ADDENDUM

Date:	20 August 2007	
To:	Contractors	
From:	Darrell Hunting, DFCM – Project Manager	
Reference:	UCAT – BATC West Campus Renovations and Improvements. DFCM Project No. 07138210	
Subject:	**Addendum No. 1**	
Pages	Cover Page	1 page
	Revised Schedule	1 page
	Addendum	2 pages
	Details	8 pages
	Spec section 09111	5 pages
	Spec section 09671	4 pages
	Prior Approvals	1 page
	Total	**22 pages**

addendum 001

project: BATC Bourns Building Remodel

C1 AE 101 - PLAN DETAIL @ STUD WALL TO TILT UP

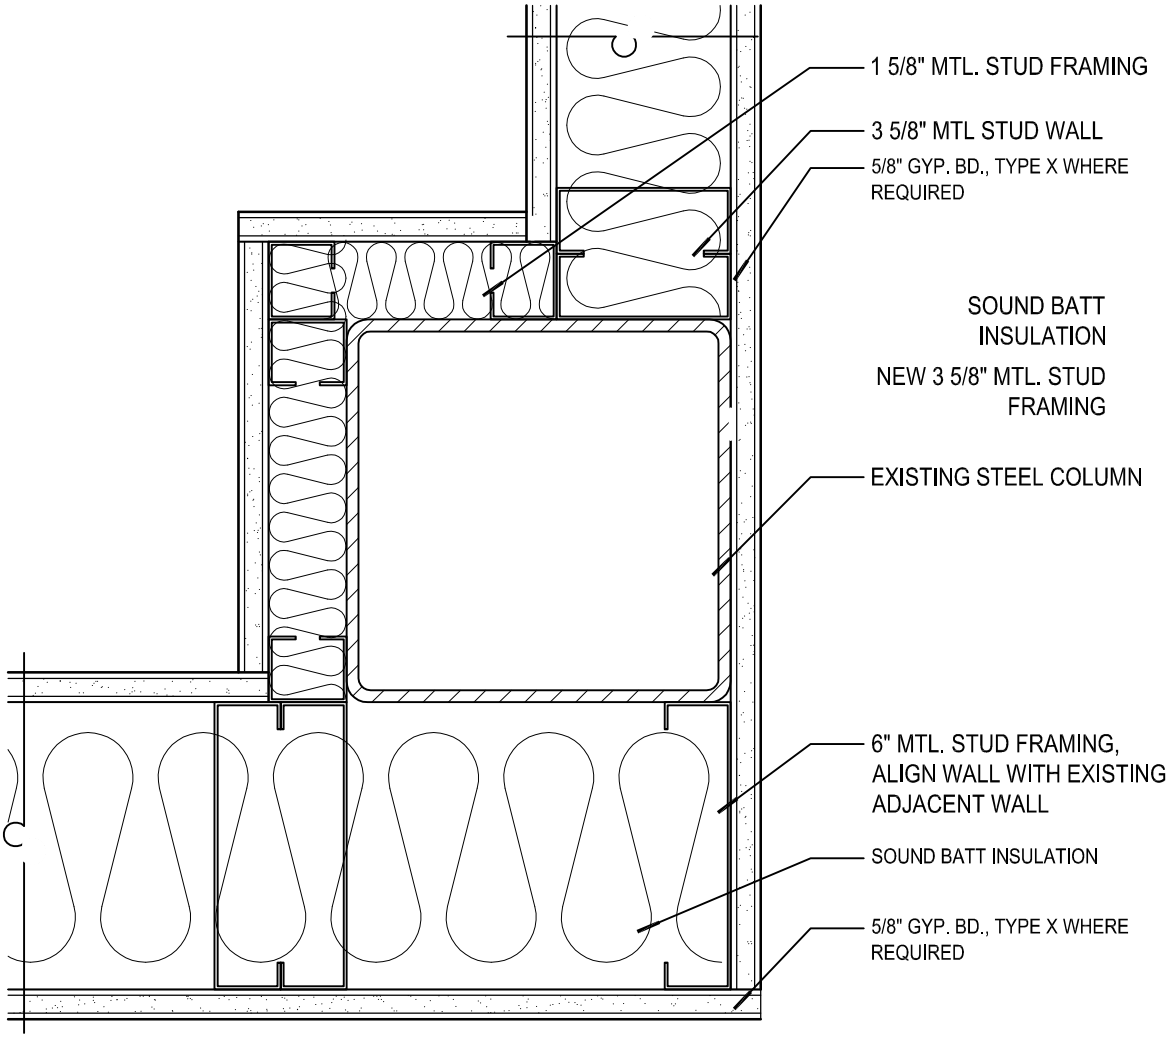
Item	Description
AE 101	Wall Types Legend - all new stud walls to be steel studs as per new Wall Types Legend, use wood studs only at repair of existing stud walls. See attached revised legend ADD 001.
C1/AE 101	Detail revised with metal studs. See attached ADD 002.
A3/AE 101A	The dimensions have been revised to reflect metal studs instead of wood studs for new walls. See attached ADD 006.
A6/AS001	Existing concrete driveway approach to remain, provide new concrete slab at door threshold as indicated.See attached revised detail ADD 007
A1/AE 101	Detail revised with metal studs. See attached ADD 004.
B1/AE101	Detail revised with metal studs. See attached ADD 003.
A2/AE 101	Detail revised with metal studs. See attached ADD 005.
A3/AE101	Door to existing boiler room to remain. See attached partial plan ADD 008
B1/AE111	All studs to be steel.
A1/AE111	All studs to be steel.
D101	Door to existing boiler room to remain. See attached partial plan ADD 008.

A6 AS 001 - SILL @ DOOR 101

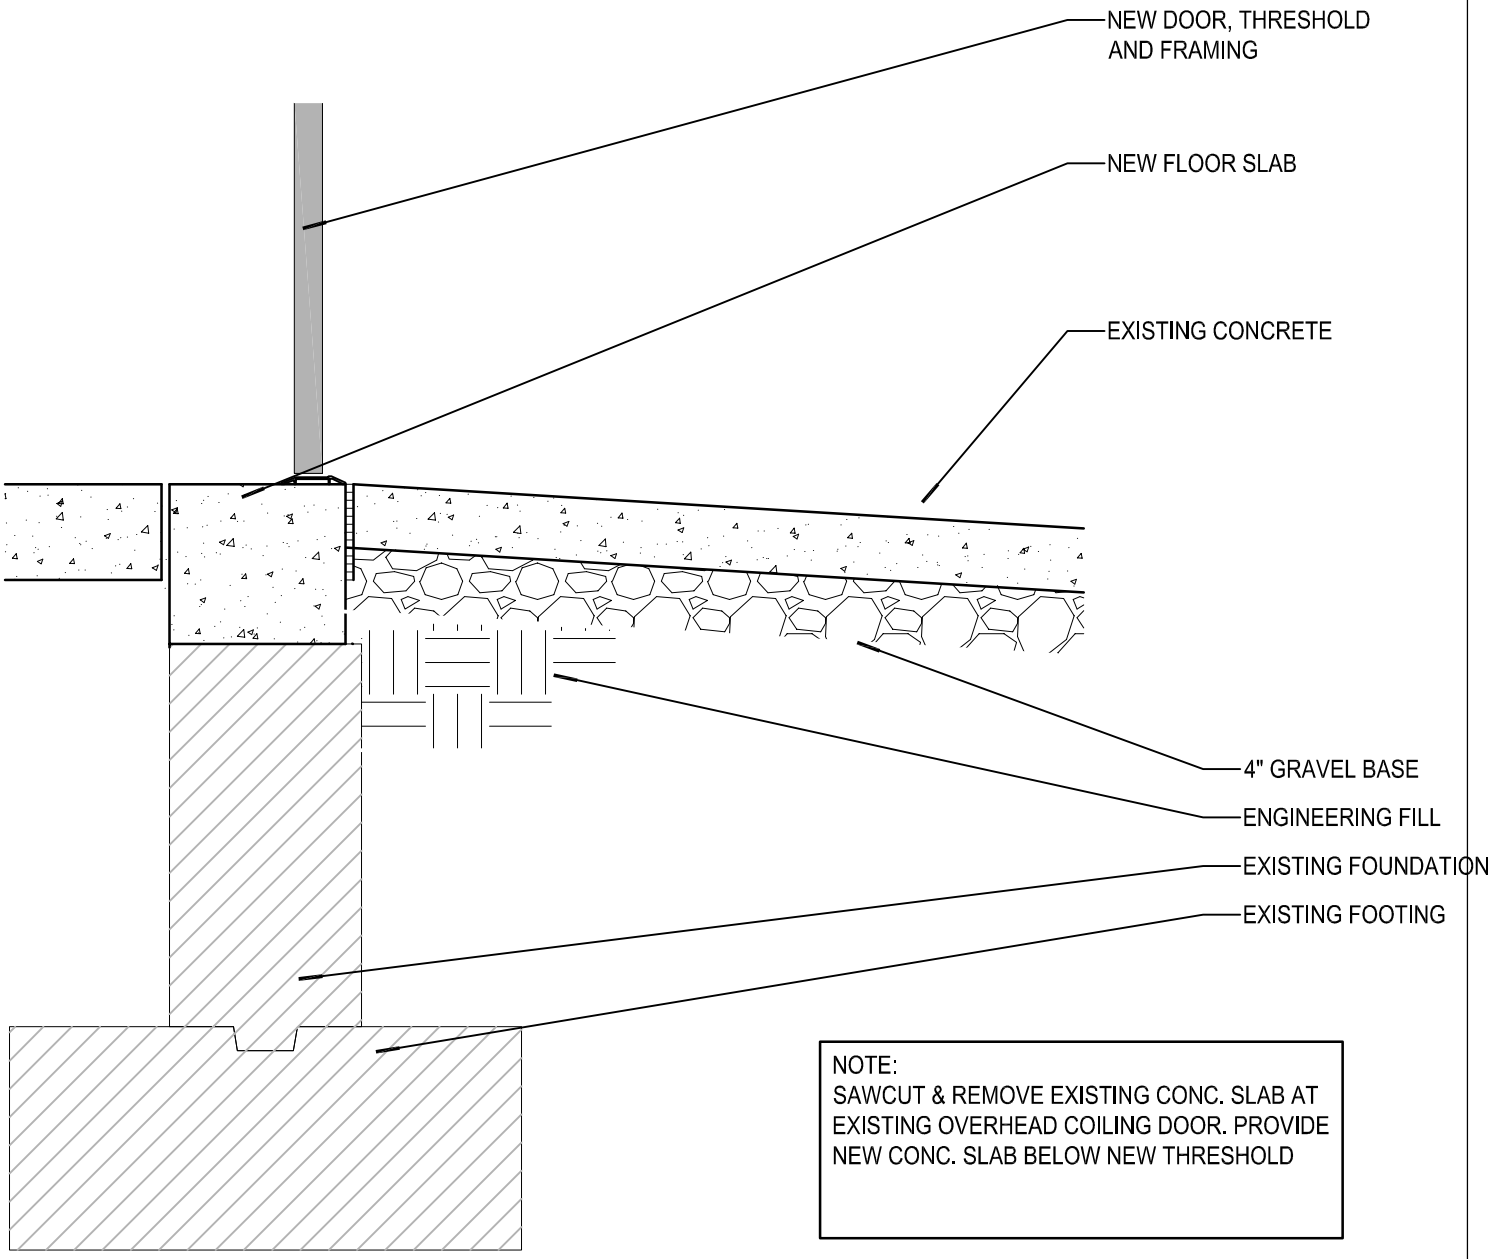
NOTE:
SAWCUT & REMOVE EXISTING CONC. SLAB AT EXISTING OVERHEAD COILING DOOR. PROVIDE NEW CONC. SLAB BELOW NEW THRESHOLD
